Detailed Site Plan McDonald's Landover

DSP-19060

STAFF REPORT

SUBJECT: Detailed Site Plan DSP-19060
McDonald's Landover

ELEVATIONS

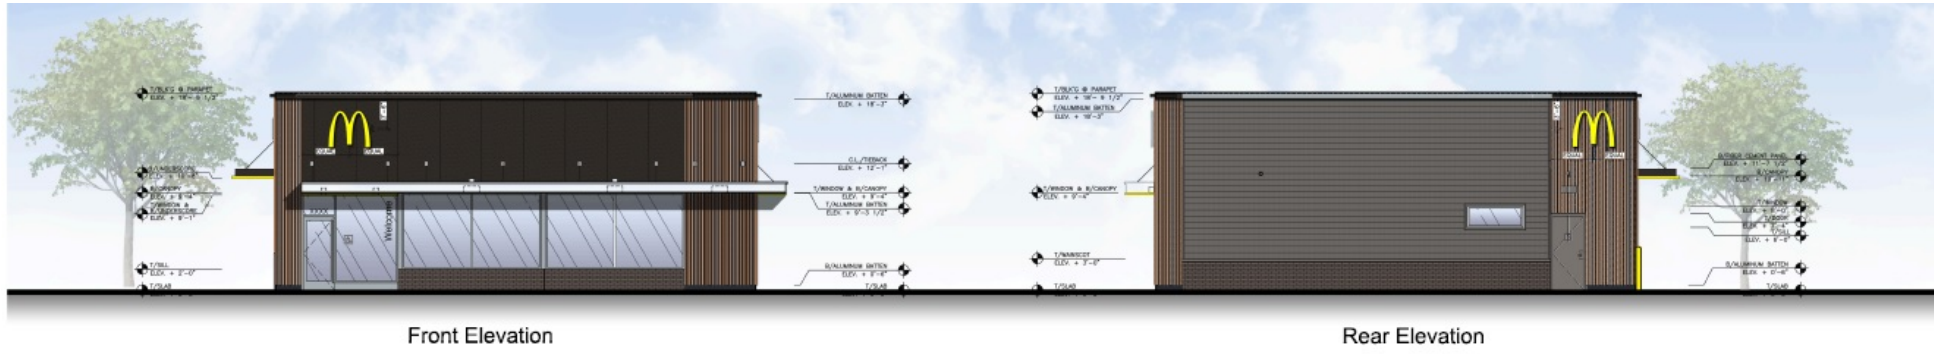
- **General Site Standards and Guidelines: Secondary Facade (page 538) -** Secondary façades of buildings must not have long expanses of blank wall. Architectural elevations submitted with the DSP show the northern and western

façades include long expanses of blank wall. The applicant has proffered to revise elevations to include appropriate articulation and a condition has been included in the Recommendation section to require such, prior to certification of the DSP. Therefore, an amendment will not be necessary.

- d. Revise architectural elevations to provide additional articulation and visual interest on the northern and western façades, in accordance with applicable development district standards.
- e. Provide Military Installation Overlay Zone height calculations to demonstrate conformance with Section 27-548.54(e)(2)(B) of the Prince George's County Zoning Ordinance.
